REMARKS

This Response is filed in response to the Office Action mailed September 9, 2005. Claims 1-32 are pending in this application. Claims 1-32 were rejected by the Office Action mailed September 9, 2005. Claims 23 and 27 were rejected under 35 U.S.C. § 112 for lack of antecedent basis. Claims 1-3, 5-10, and 12-32 were rejected under 35 U.S.C. § 102(e) as being anticipated by US Patent No. 6,002,184 to Delson et al (hereinafter "Delson"). Claims 4 and 11 were rejected under 35 U.S.C. § 103(a) as being unpatentable over Delson in view of the application's admitted prior art. Claims 10, 20, 29 and 30 were objected to for informalities in the claim language.

AMENDMENTS TO THE DRAWINGS

FIG.2

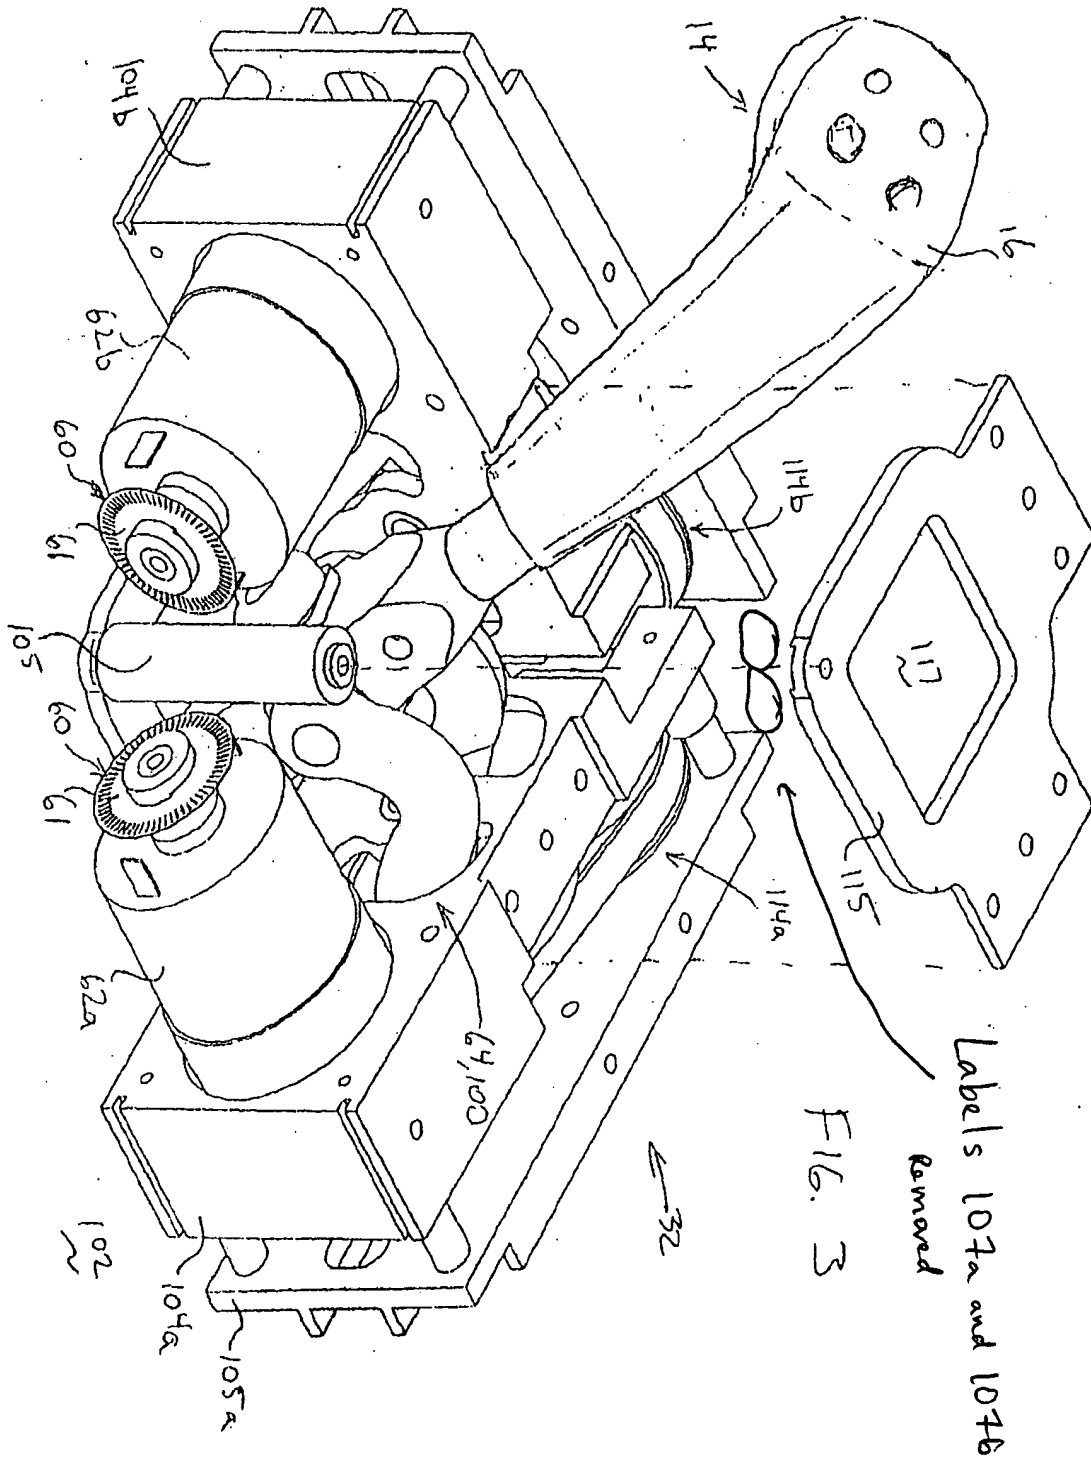
The Examiner objected to Figure 2 for failing to include label 59 that was referenced in paragraph 32 of the specification. Applicant has amended Figure 2 to include previously omitted element label 59.

In Figure 2, previously omitted element label 59 that is found in paragraph 32 of the specification has been added.

Label 59
added

FIG.6

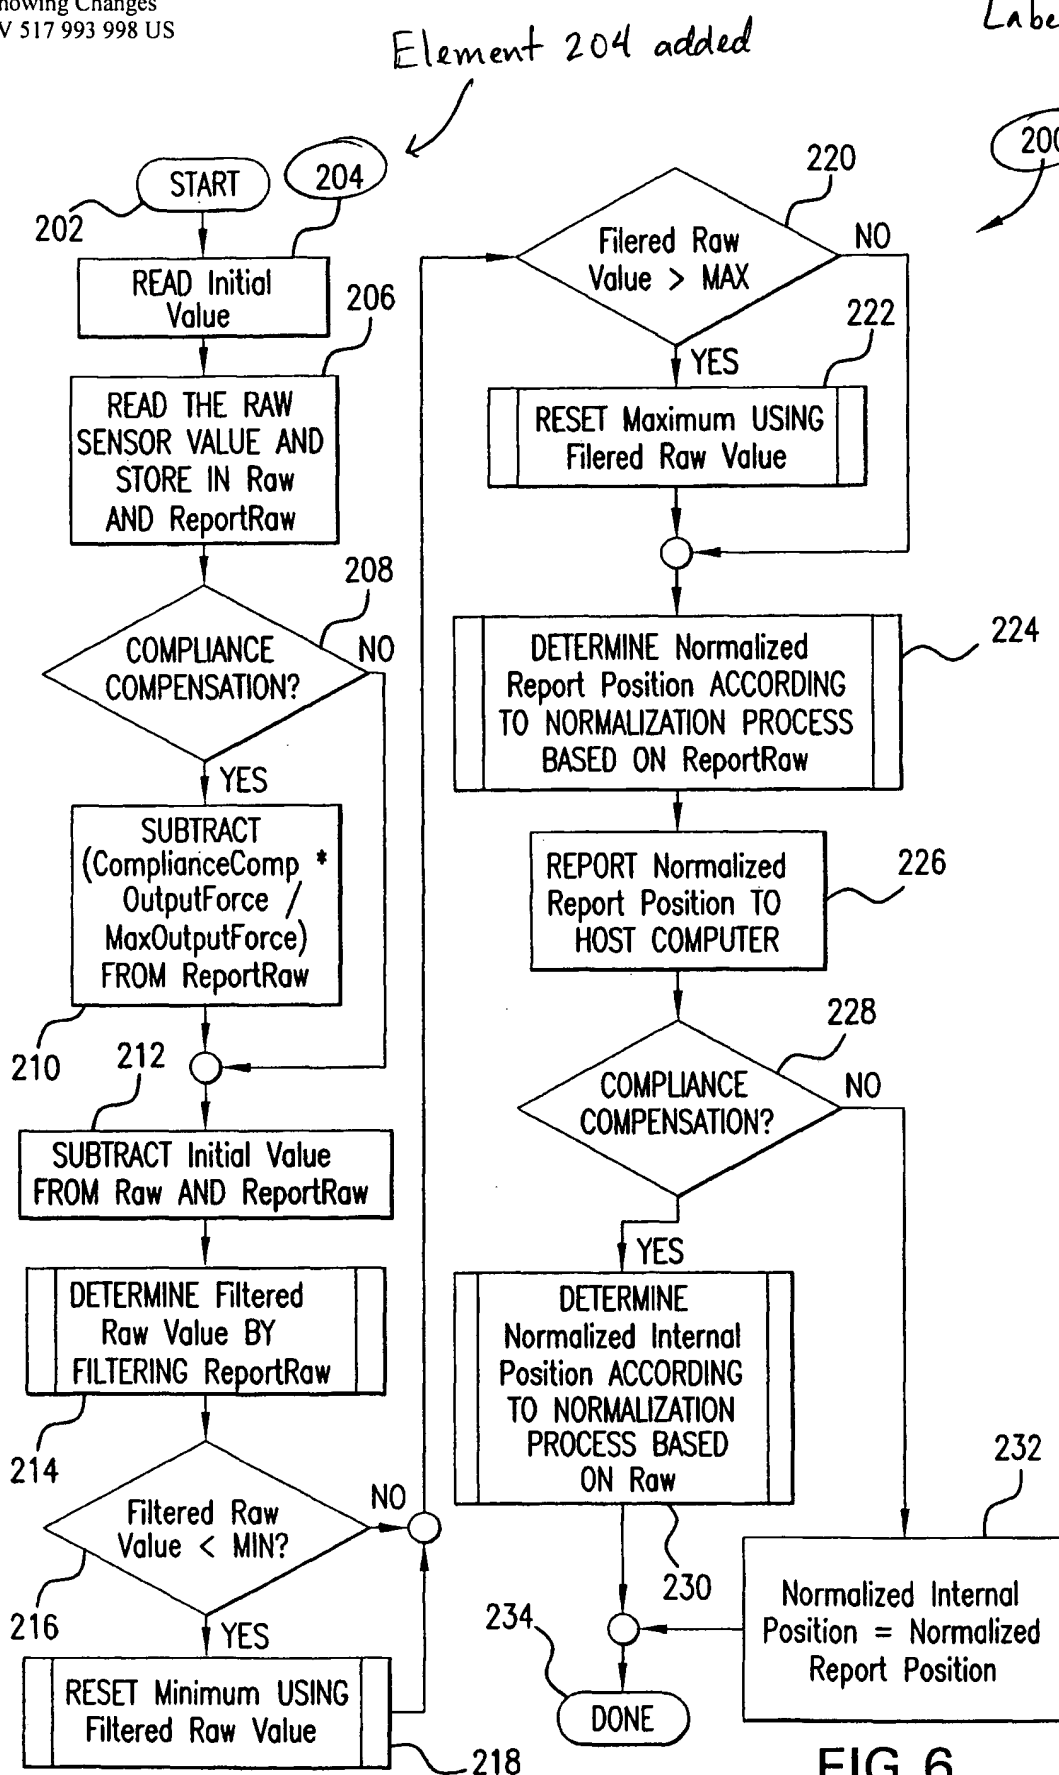
The Examiner objected to Figure 6 for failing to include labels 200 and 204 that were referenced in paragraphs 64 and 68, respectively, of the specification. Applicant has amended Figure 6 to include previously omitted element label 200 and previously omitted element 204.

In Figure 6, previously omitted element label 200 and element 204 that are found in paragraphs 64 and 68, respectively, of the specification have been added.

FIG. 10

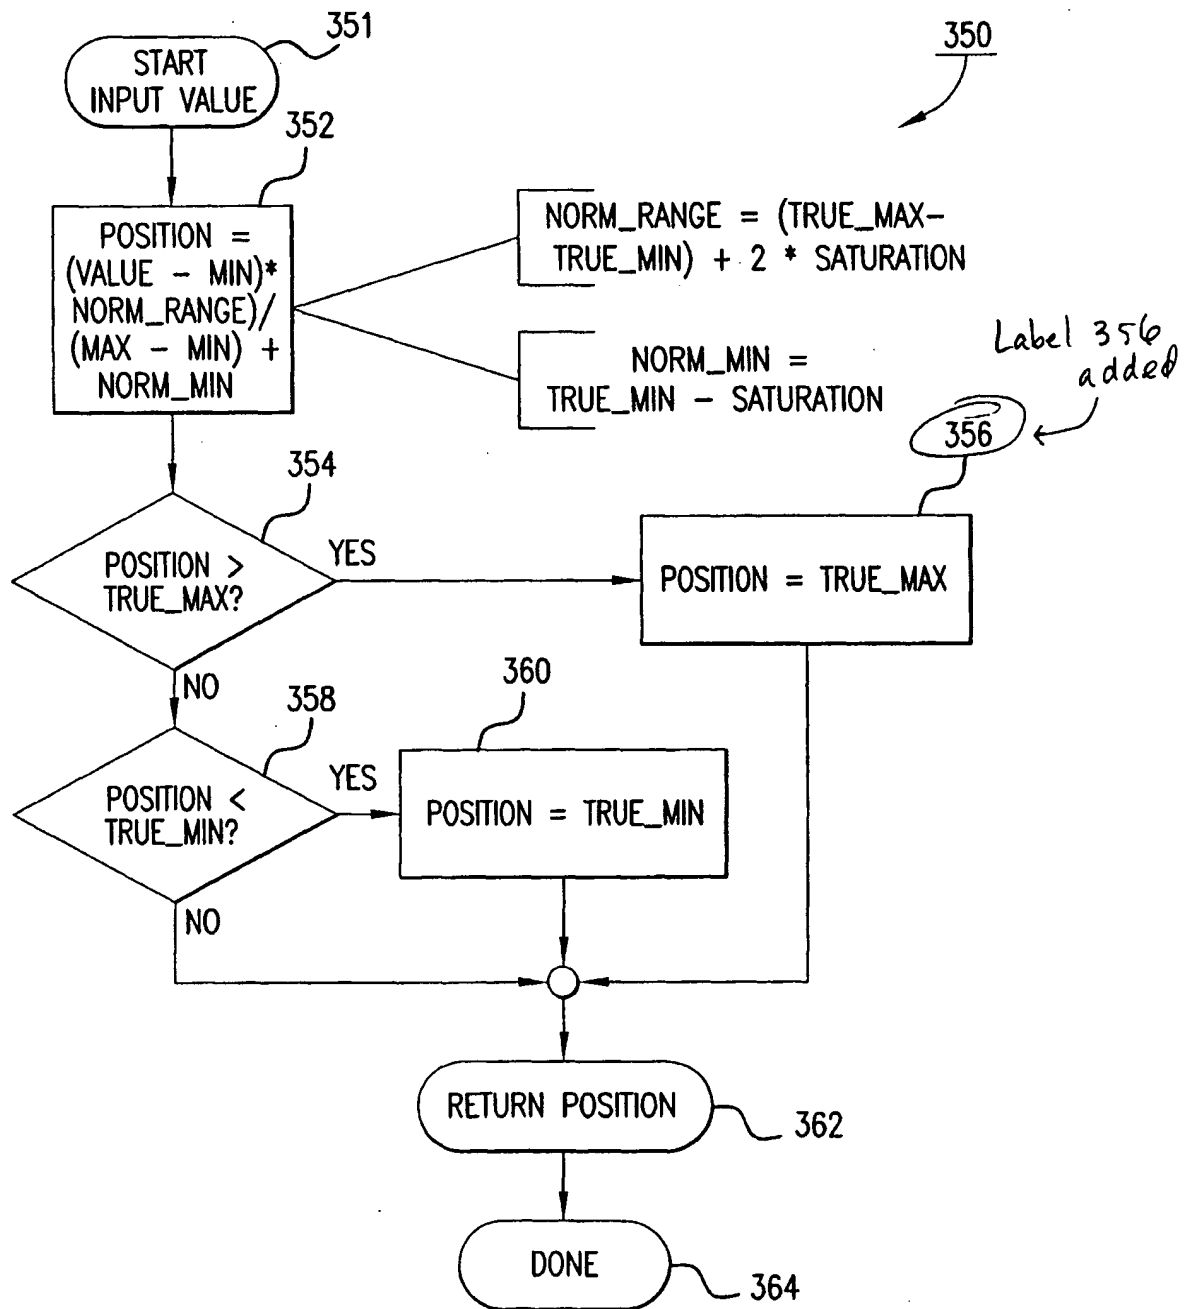
The Examiner objected to Figure 10 for failing to include label 356 that was referenced in paragraph 86 of the specification. Applicant has amended Figure 10 to include previously omitted element label 356.

In Figure 10, previously omitted element label 356 that is found in paragraph 86 of the specification has been added.
